ENGINEERING CLOSURE REPORT
BIG ISLAND MINING (XAT-7)
AND
ATCHAFALAYA SEDIMENT DELIVERY (PAT-2)

AS-BUILT CONSTRUCTION PHASE

DECEMBER 1998

Appendix	A	Project Field Changes
Appendix	B	Project Dedication Ceremony
Appendix	C	Benchmarks on BIM and ASD
Appendix	D	Surveys
Appendix	E	As Built Channels and Disposal Areas

PARTIAL PLAN
REVISION TO NATAL CHANNEL
(FIELD CHANGE NO. 2)

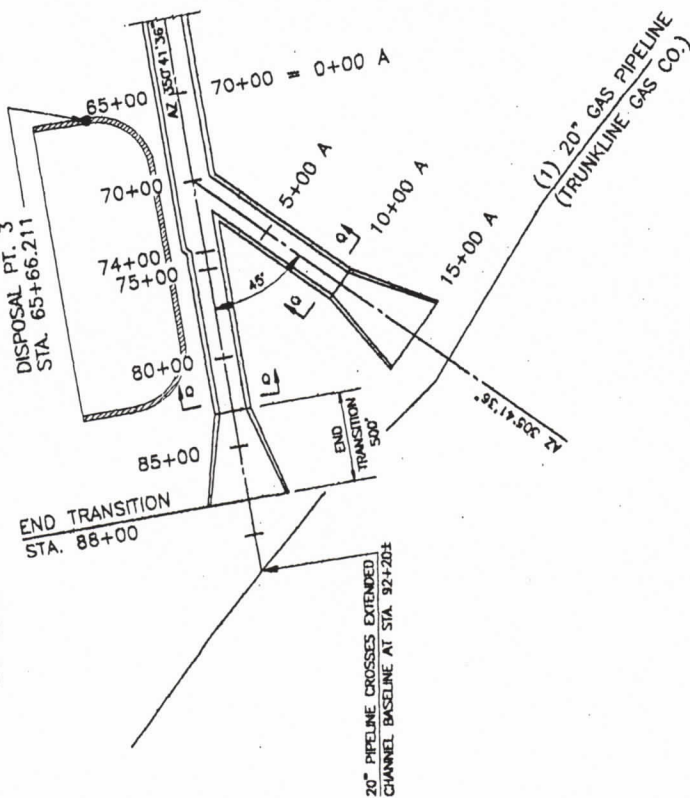
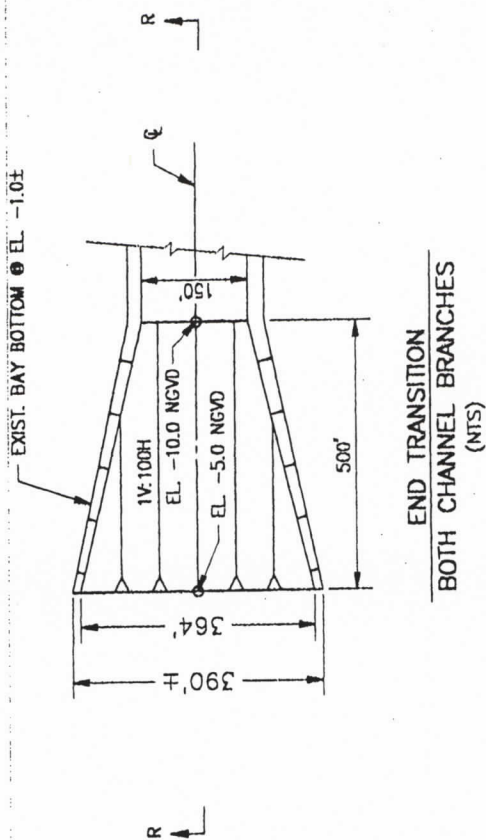
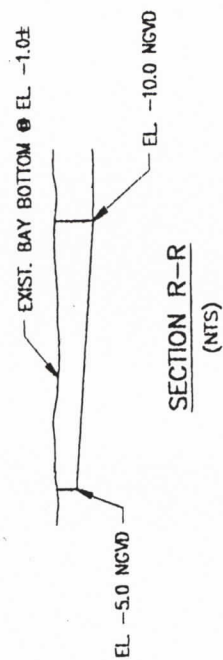
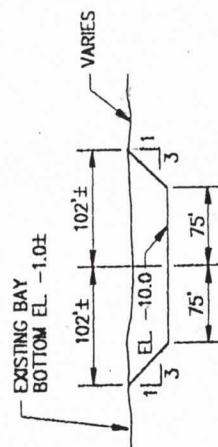
RE: BIM/ASD Project Field Change No. 2
Revision to Natal Channel Alignment Between Sta. 70+00 and End.
BCG Project 30594-1.

As the Engineer of Record and in accordance with the project specifications we are forwarding Field Change No. 2 to you for implementation into the project. This change calls for extending and revising the bottom width of Natal Channel from station 74+00 to the new end station 88+00. Also, adding Branch A channel at station 70+00 with a deflection angle of 45° and extending for 1500 feet in an effort to reach deeper bay bottoms. The new channel bottom width between Sta 74+00 and end, and the Branch A channel between Sta 0+00A and end is reduced to a 150 foot bottom at a design depth of -10.00 NGVD. The channel side slopes remain at IV:3H. In addition, there is a flair end transition on both channels as shown on the enclosed Field Change No. 2 drawing dated March 10, 1998. This change in cross section and channel extension is estimated to require the total dredging in Natal Channel of approximately 657,000 cubic yards; and is to be constructed at the unit bid price of \$1.50 per cubic yard. This change results in no changes to the contract unit prices and stays within the estimated bid quantity item no. 510 of the contract.

**FIELD CHANGE NO. 3
ALTERNATE CHANNEL D AND REVISIONS
TO DA-3, DA-4 AND DA-5**

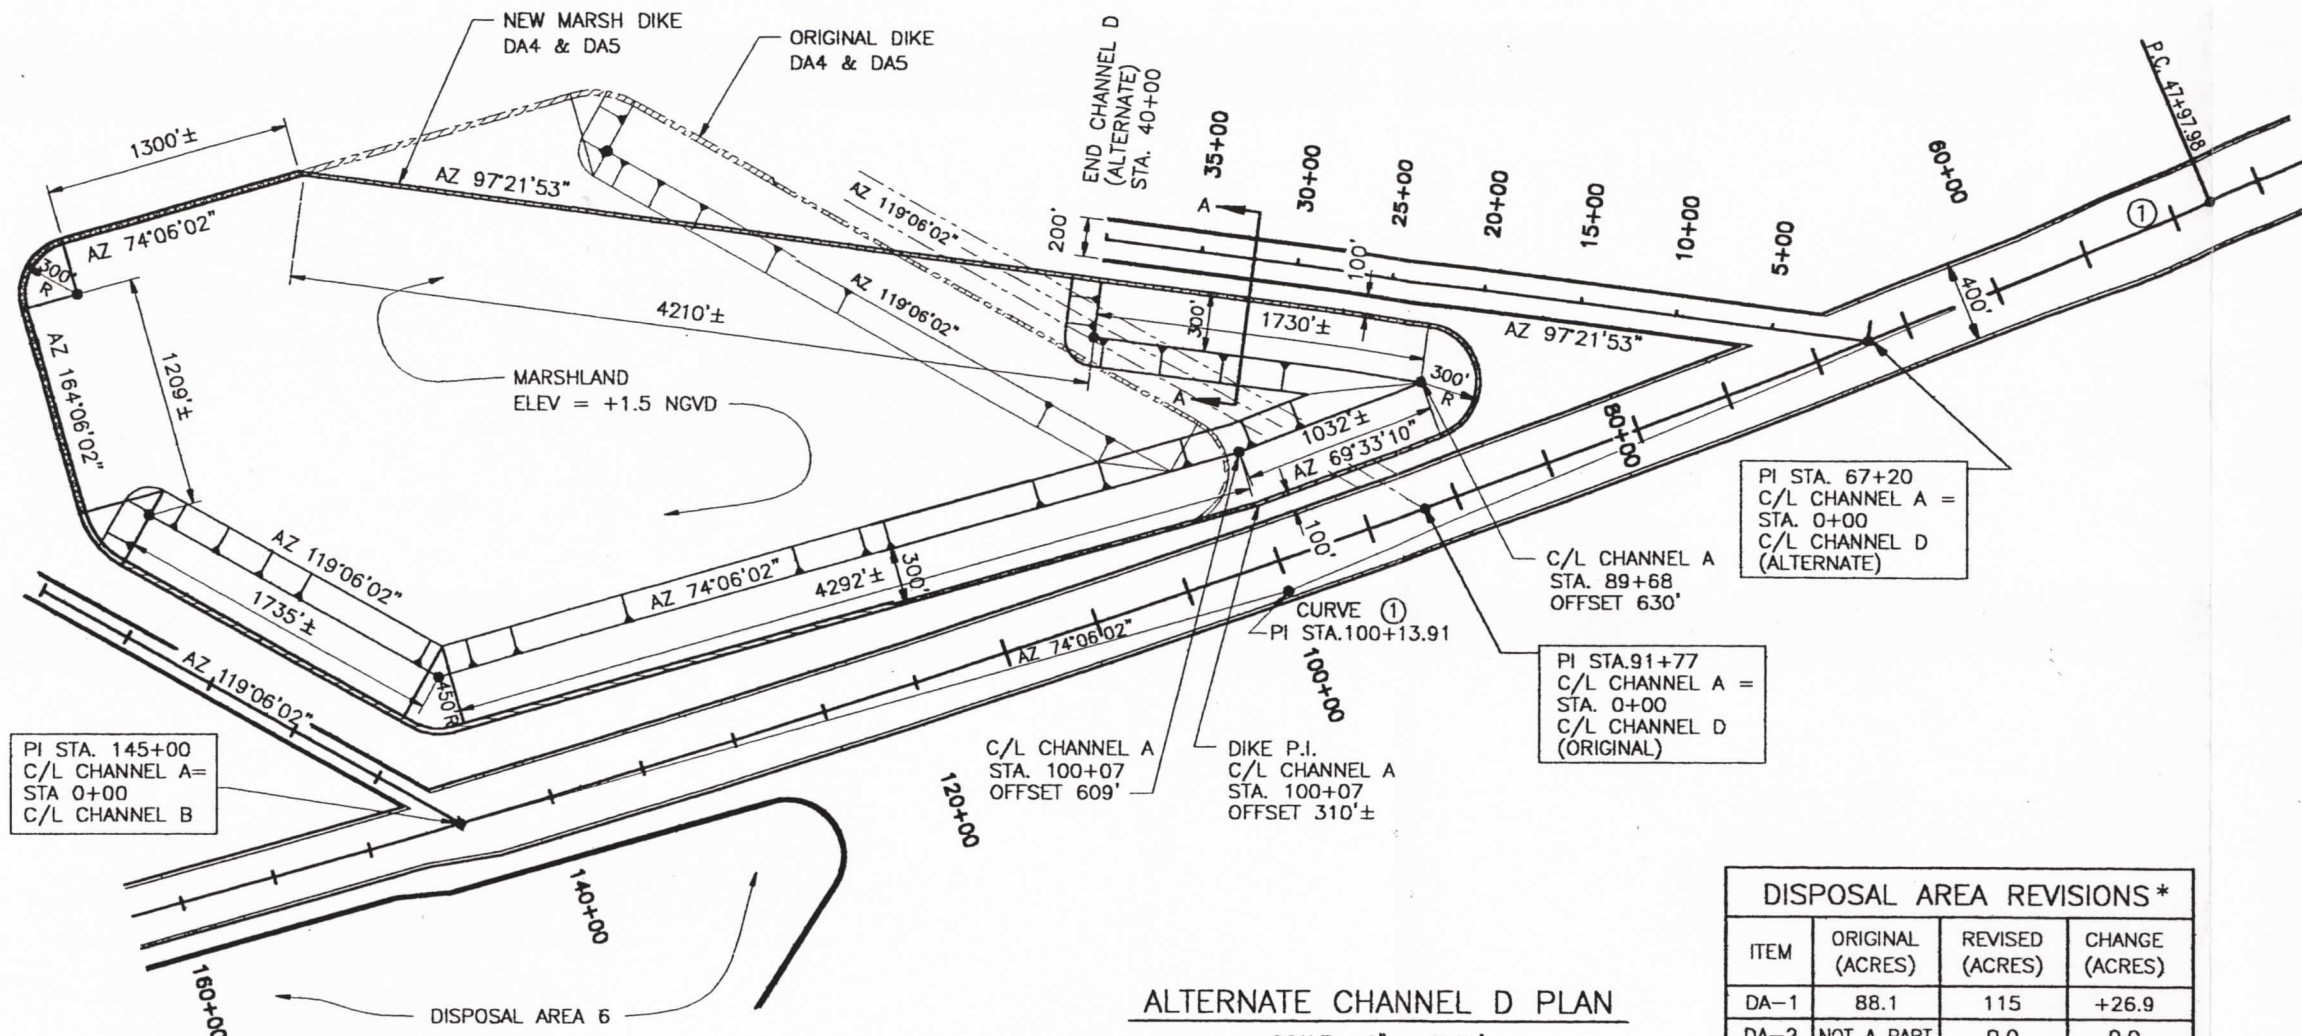
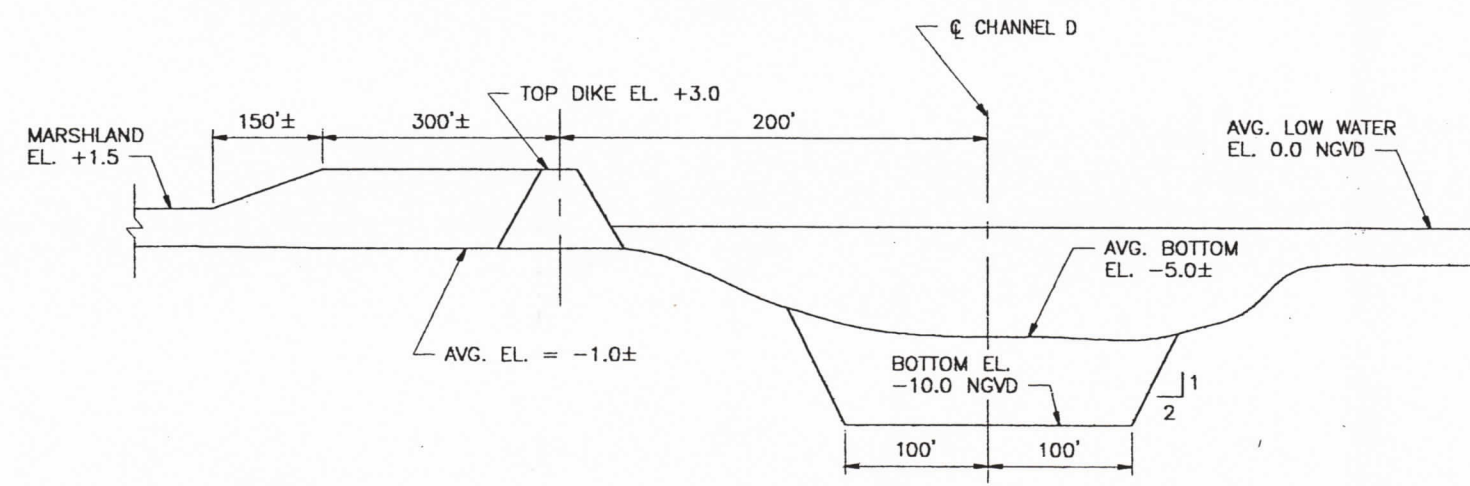
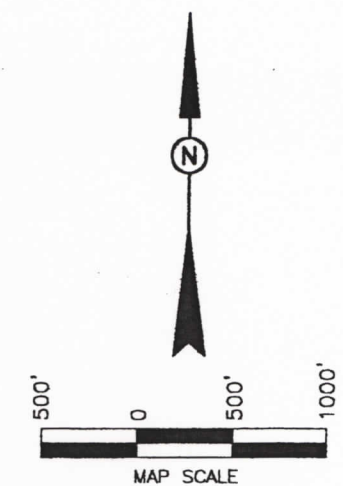
RE: BIM/ASD Project Field Change No. 3
Revise Channel D Alignment,
Delete Disposal Area No. 3
And Revise Disposal Area No. 4/5

1. Realigning the originally configured Channel D of the construction plans, to begin work at Channel A c/l station 67+20 and construct a 200' bottom to Elev. -10.0 NGVD. The new Channel D extends along a centerline as azimuth of 97° 21' 53" for 4000 feet, ending work at Channel D (c/l station 40+00).

2. Delete Disposal Area No. 3 from the project in its entirety.
3. Modify Disposal Area 4/5 to be contiguous to the new Channel D alignment, all as shown on "Field Change Drawing No. 3", dated June 1998 (copy attached).

4. My letter dated April 19, 1998, entitled "Field Change No. 3" is to be voided since Channel D is realigned rather than extended. This present letter which describes required Field Change No. 3 superceeds my letter of April 19, 1998. The reason for realigning Channel D results from review of contractor's Before Dredging Surveys for the original D and Disposal Area No. 3. This survey shows an existing shallow natural channel that has developed having an average depth to -4.0 NGVD along the alignment of the new Channel D, described in paragraph 1 above. Following this in-situ channel affords a better hydraulic solution, since otherwise, there would be two channels side by side. Also, DA No. 3 has to be deleted since there is insufficient space between the new Channel D and the main land to construct DA No. 3.

5. Disposal Area 4/5 is revised and expanded along its perimeter to be contiguous to the new Channel D alignment, the optional back dike alignment for DA No. 4/5 has been shifted to follow the -1.0 NGVD contour elevation of the bay bottom. Some field deviation from alignment shown may be required to stay in shallow water (-1.0 NGVD).

<u>Item</u>	<u>Original</u>	<u>Revised</u>	<u>Change</u>
1.	Channel D:	101,000 cy	174,345 cy	+73,345
2.	DA No. 3:	+82.6 ac	0.0	-82.6 ac
3.	DA No. 4:	+92.68 ac	+91.1 ac	-1.6 ac
4.	DA No. 5:	260 ac	219 ac	-41.0 ac

FIELD CHANGE NO. 4 - DRAWING NO. 1

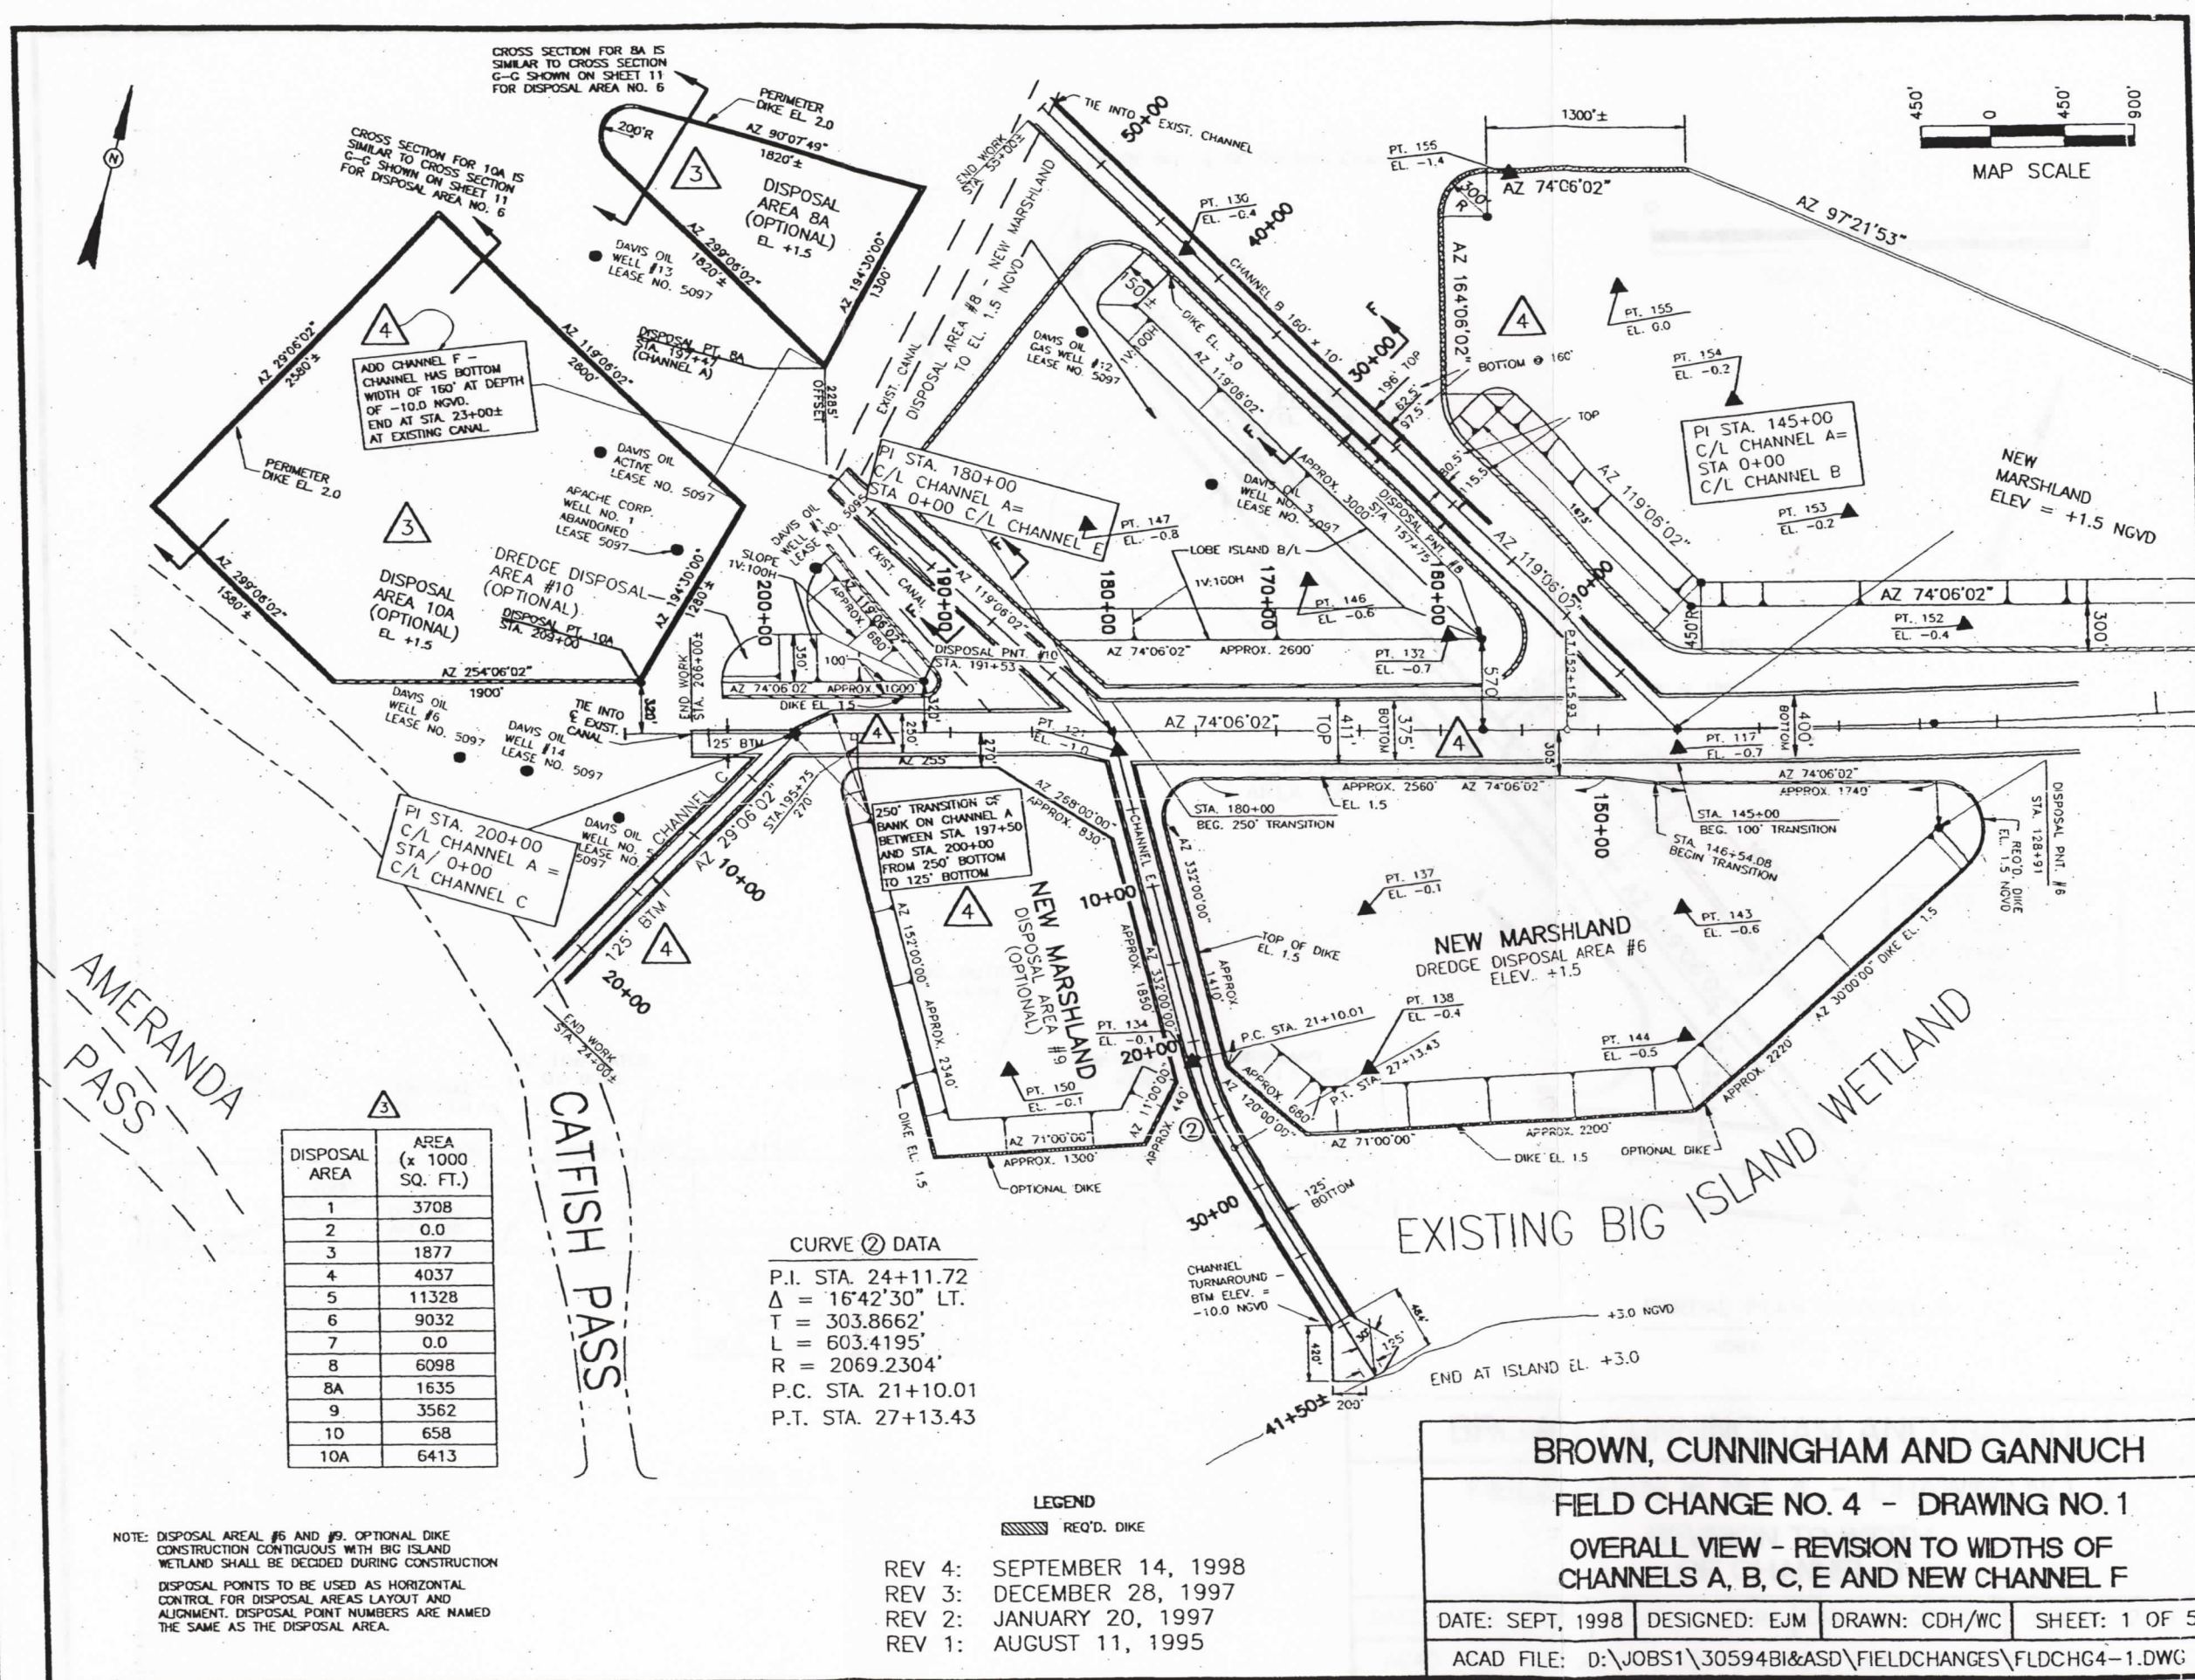
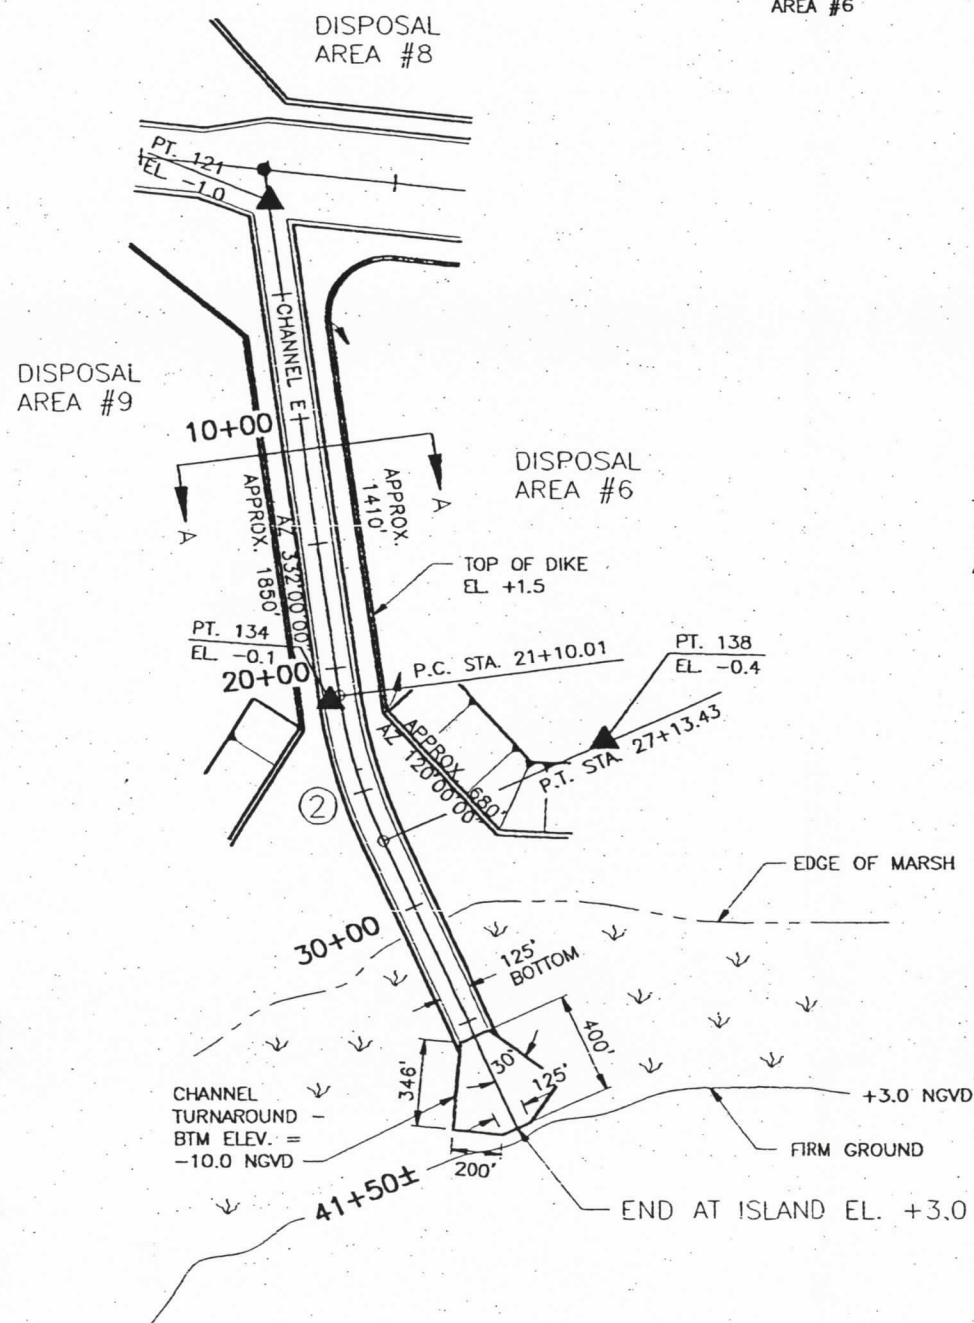
Re: BIM/ASD Project Field Change No. 4
Revised Channel Widths For "A", "B", "C", and "E" and add Channel F.

This letter shall confirm our discussions on completing the Big Island Mining project based upon the actual "Before Dredging Surveys", recently completed. In an effort to achieve the original design intent of this project and to maximize creation of marshlands acres we direct you to revise the following channels:

In addition, add new Channel F starting at station 180+00 of Channel A and extending on an azimuth of 119° 06' 02" to station 22+00± to intersect with the existing pipeline canal. Channel F shall have a bottom width of 160 feet to -10.0 NGVD. Also, extend the Disposal Area No. 8 dike along new Channel F with the bucket dredge to station 20+00 of Channel F. Contractor shall conduct a magnetometer survey prior to doing work along Channel F to insure that no pipelines exist.

FIELD CHANGE NO. 4 - DRAWING NO. 4

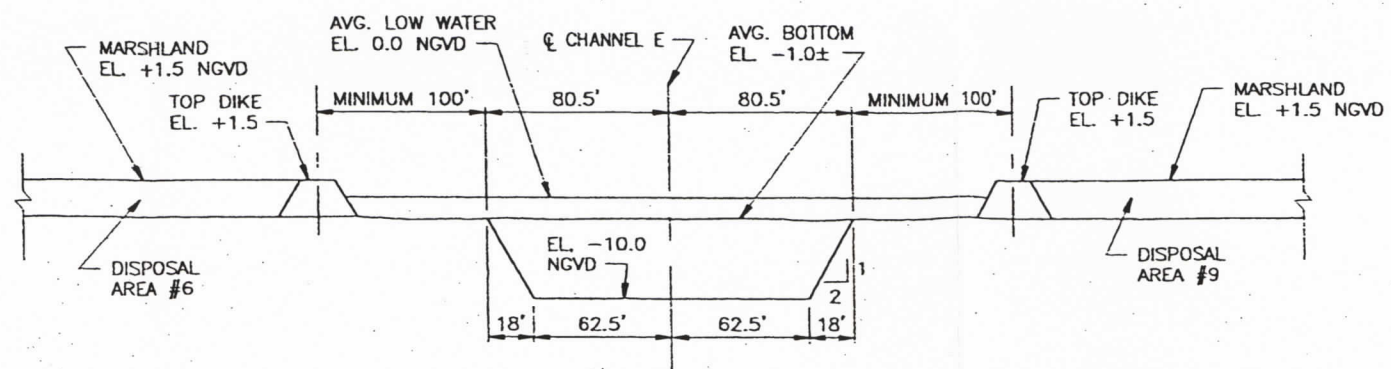
REVISION TO WIDTH
OF CHANNEL E
